Access Compliance Report

Public Rights-of-Way

(Curb Ramps)

Intersection ID: 49292	Main Street: ROYAL_WINCHESTER_DR	Cross Street: CHAMBERLIN_RD	Location: NE
ADA ID: C12210422234	Ramp Type: PerpDiag	Initial Pass/Fail: Fail	Overall Compliance: No
		Severity Score: 22.5	
Codes/Mitigation Info/Possible Solution		Field Measurements/Component Compliance

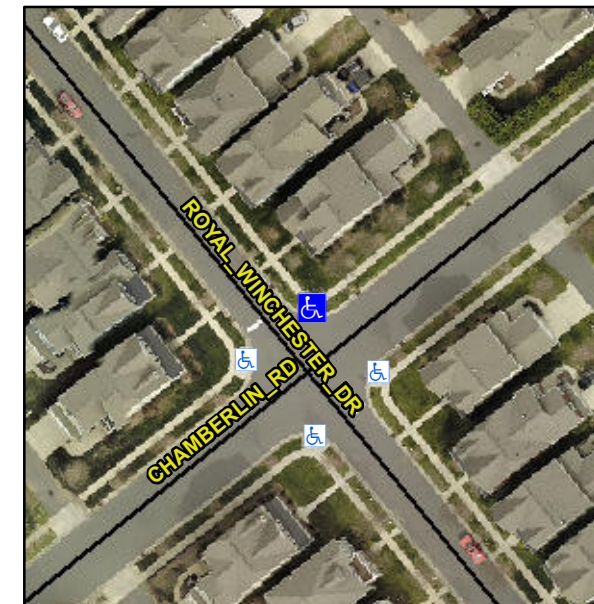
Not Found, R304.5.1, R304.2.2, R304.5.3

Compliance	Description	Data	Compliance	Description	Data
N/A	Ramp Length (in)	72.0	No	Ramp Slope (%)	8.5
No	Ramp Width (in)	45.0	No	Ramp XSlope (%)	4.0
N/A	Flare Type LT	N/A	N/A	Flare Type RT	N/A
N/A	Flare Slope LT (%)	N/A	N/A	Flare Slope RT (%)	N/A
N/A	Flare Traversable LT?	N/A	N/A	Flare Traversable RT?	N/A
N/A	Landing Length (in)	N/A	N/A	DWS Provided?	N/A
N/A	Landing Width (in)	N/A	N/A	DWS Contrast?	N/A
N/A	Landing Slope (%)	N/A	N/A	DWS Length (in)	N/A
N/A	Landing X Slope (%)	N/A	N/A	DWS Full Width?	N/A
N/A	Landing Curb? (Y/N)	N/A	N/A	DWS Offset (in)	N/A
N/A	Shared Landing?	N/A			
N/A	Gutter Ponding?	N/A	N/A	Gutter Slope (%)	N/A
N/A	Gutter Lip Ht (in)	N/A	N/A	Gutter X Slope (%)	N/A
N/A	Painted X Walk1?	No	N/A	Painted X Walk2?	No
	X Walk 1 Direction	To SW		X Walk 2 Direction	To SE
N/A	X Walk 1 Width (in)	N/A	N/A	X Walk 2 Width (in)	N/A
	X Walk 1 Slope (%)	0.7		X Walk 2 Slope (%)	2.5
	X Walk 1 X Slope (%)	2.5		X Walk 2 X Slope (%)	0.8

Remove & Replace Curb Ramp With Two New Directional Ramps or Equivalent.
